**CITY OF MEDINA, OHIO  
CITY HALL PARKING STRUCTURE STORM SEWER OUTLET INSTALLATION  
CITY JOB No.: 1073**

**ADDENDUM No. 2**  
January 21, 2021

Sheet Number: 2 of 20

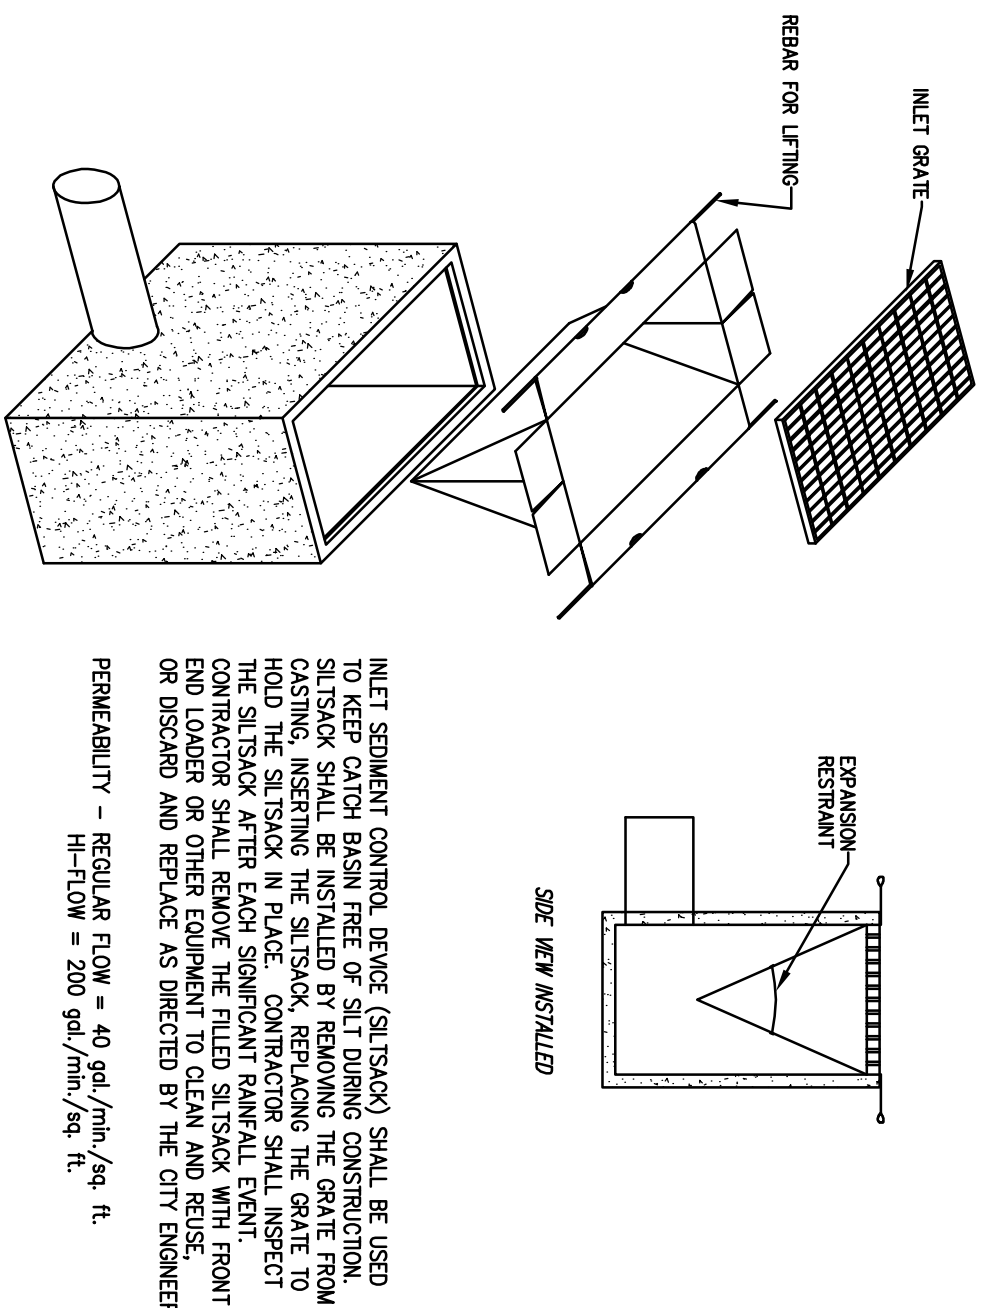
Sheet 2 of 20: The note regarding the excavation and embankment for the underground storm water chamber has been revised to reflect the revisions to the trench section and corresponding unit price items.

<b>CITY OF MEDINA</b>	
Project: CITY HALL PARKING STRUCTURE STORM SEWER OUTLET	
GENERAL NOTES / CONSTRUCTION NOTES	
Scale:	
Revisions:	SEPTEMBER 2020
Sheet Number: 4 of 20

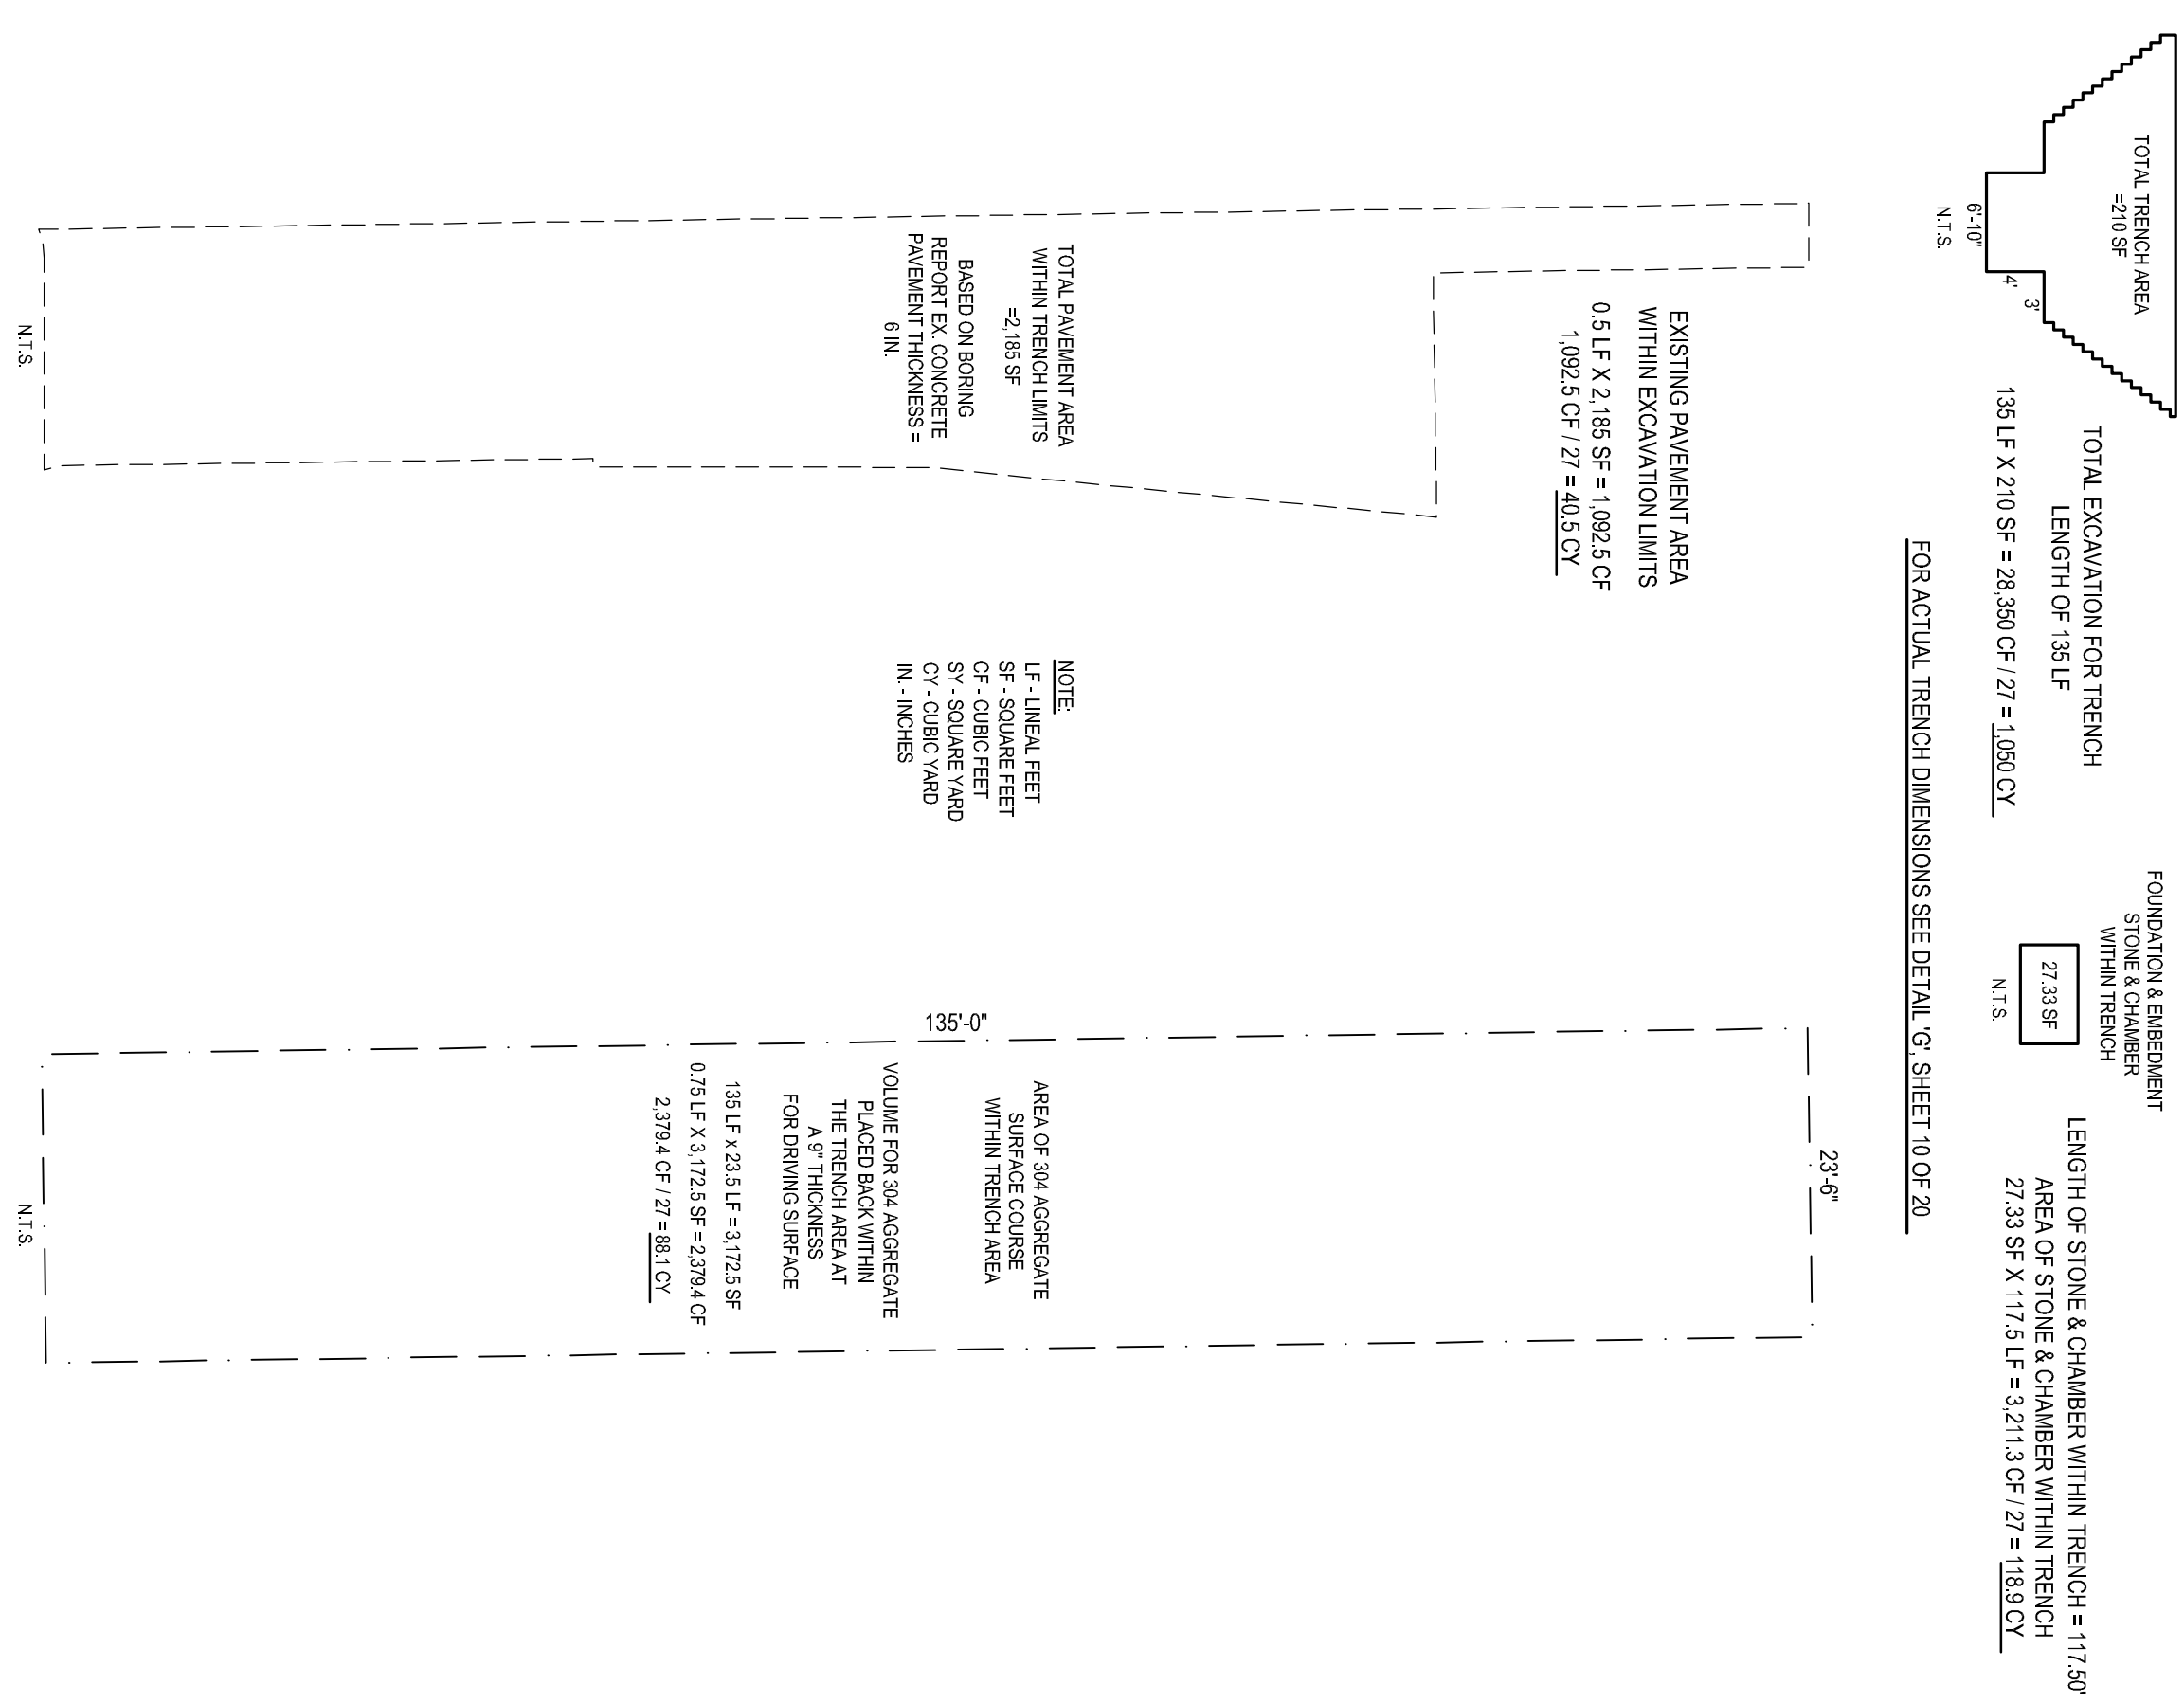
Sheet 4 of 20: The underground storm water chamber earthwork calculations and notes have been revised to reflect the revisions made to the trench section for the storm water chamber. Revisions to the notes and calculations on this sheet also reflect the

changes that have been made to the unit price pay items to allow the contractor to select an alternate means of excavation and embankment for the storm water chamber.

Sheet Number: 7 of 20

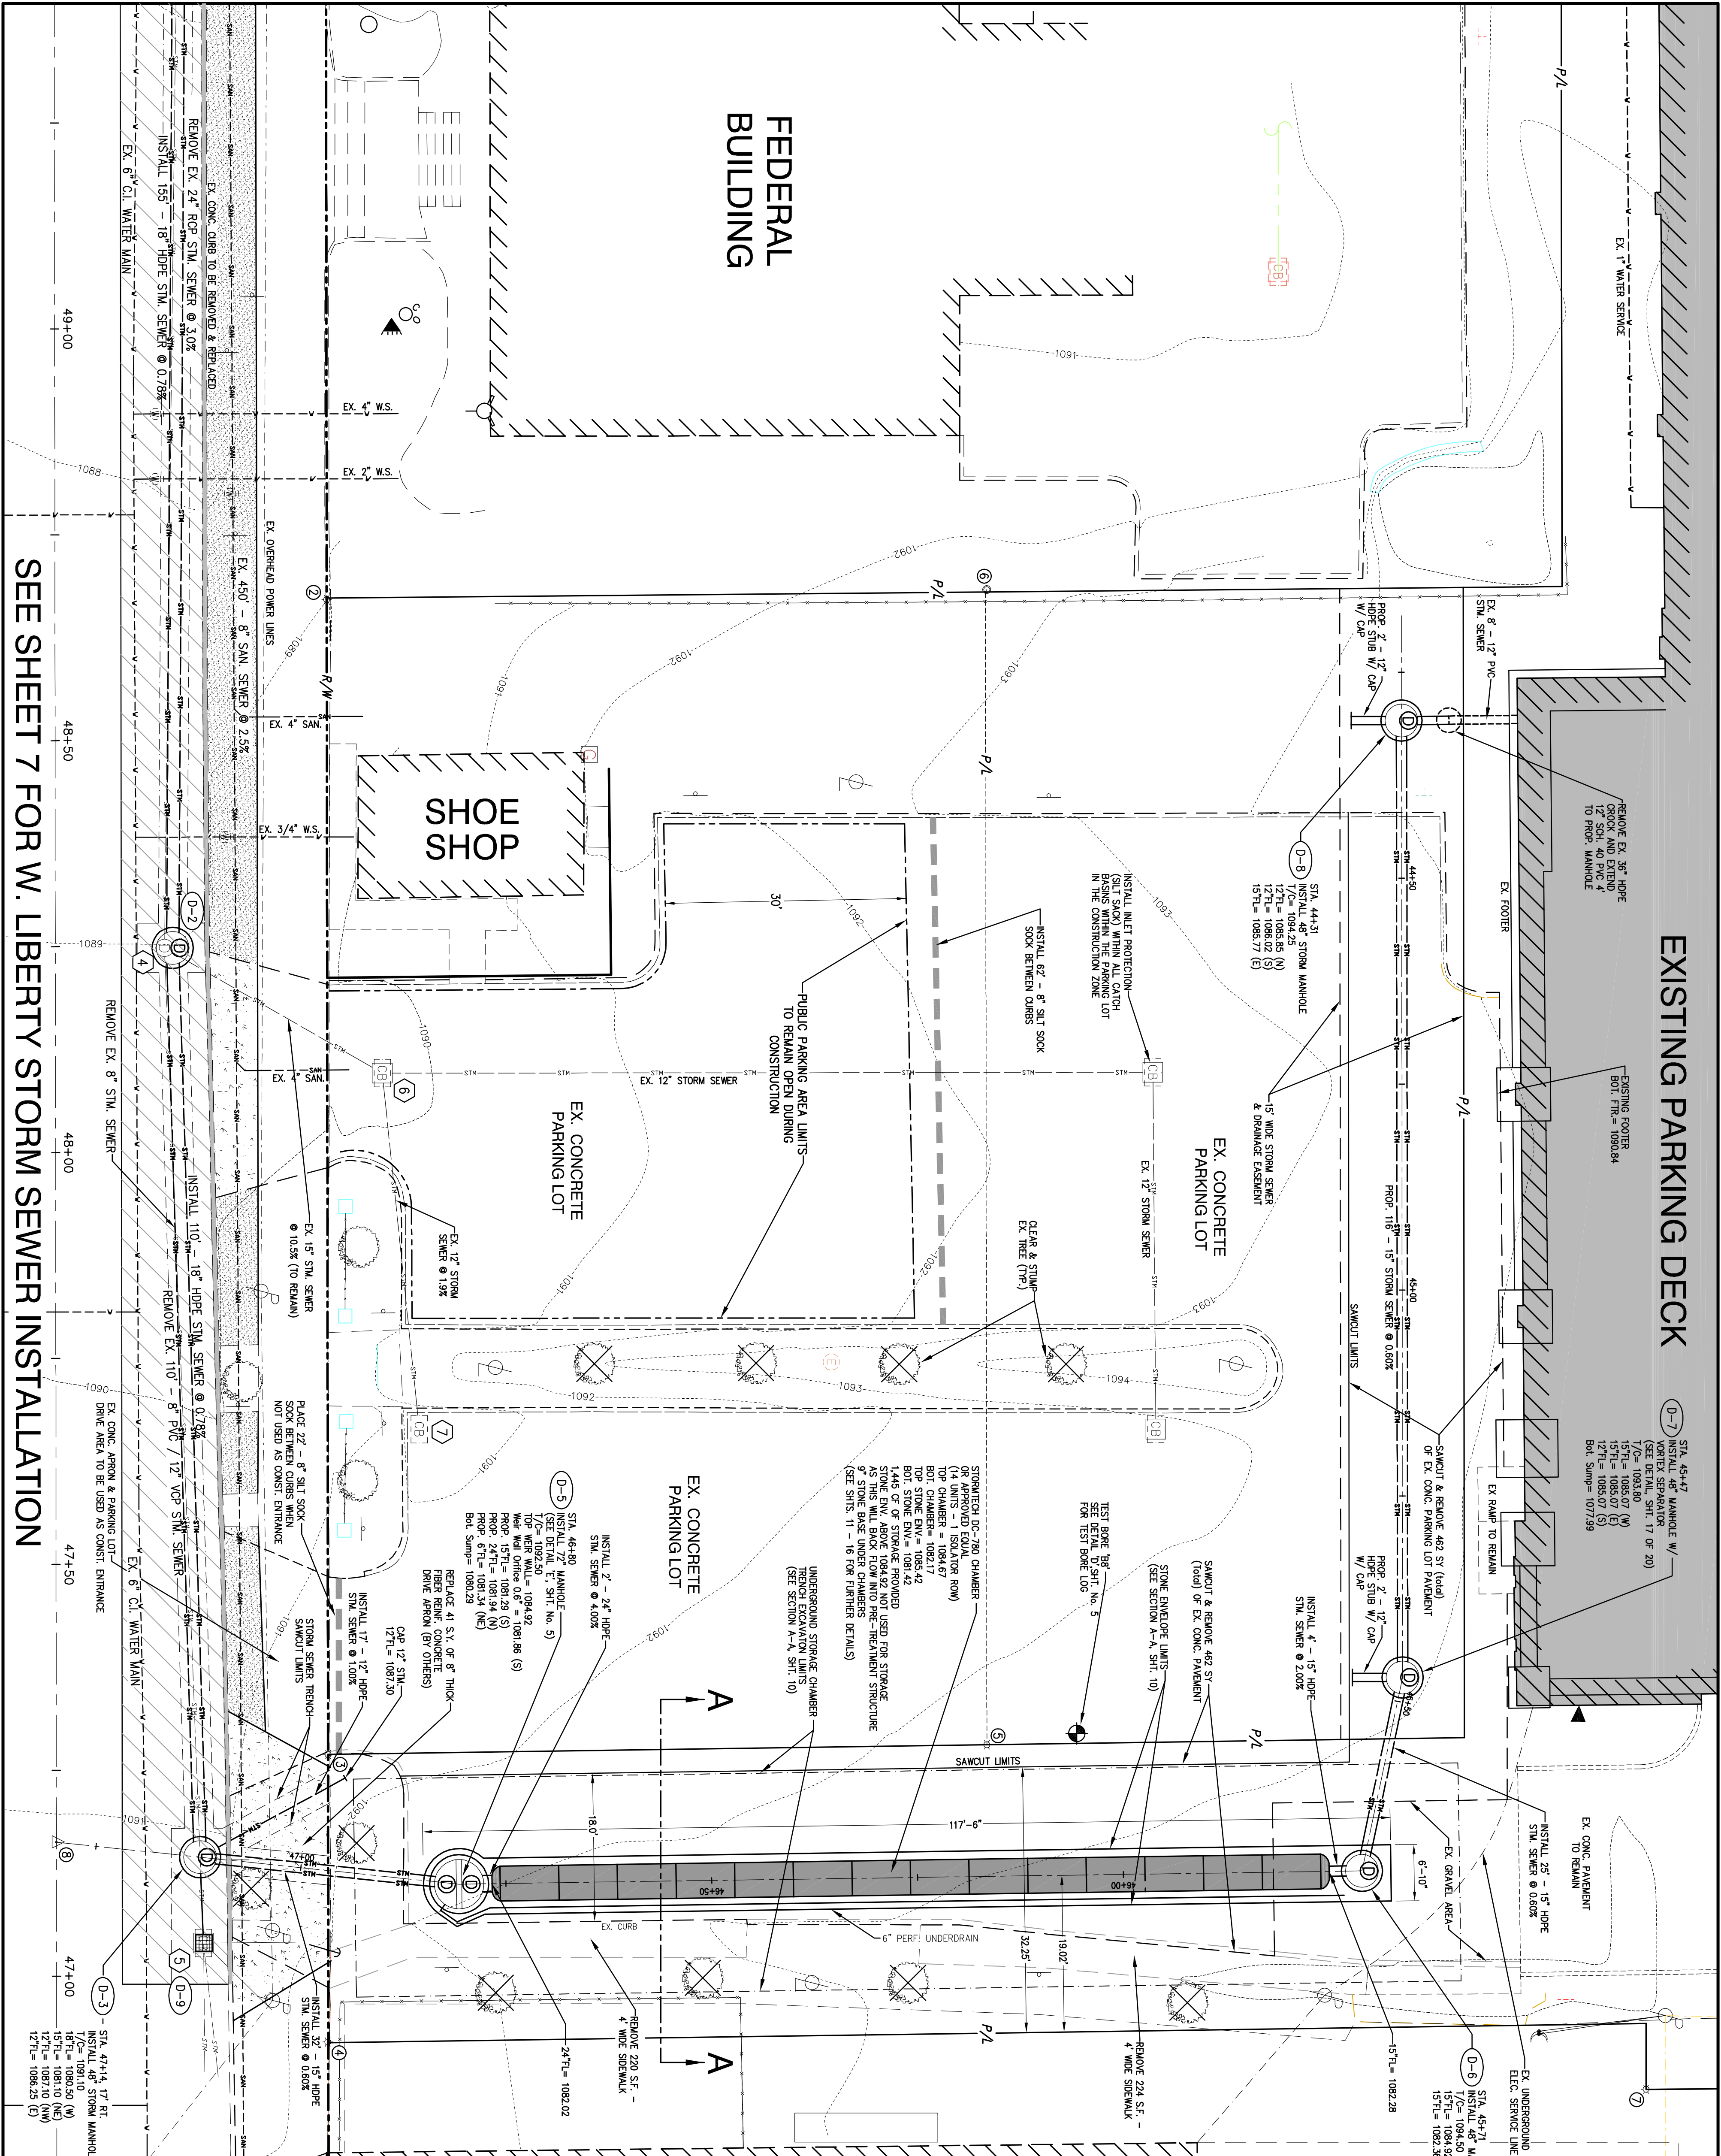
Sheet 7 of 20: The trench limits for the underground storm water chamber has been expanded from 23'-6" to 26'-6" to accommodate the revised trench section. The underground storm water chamber was shifted 1.5 feet to the west to accommodate the revised trench section.
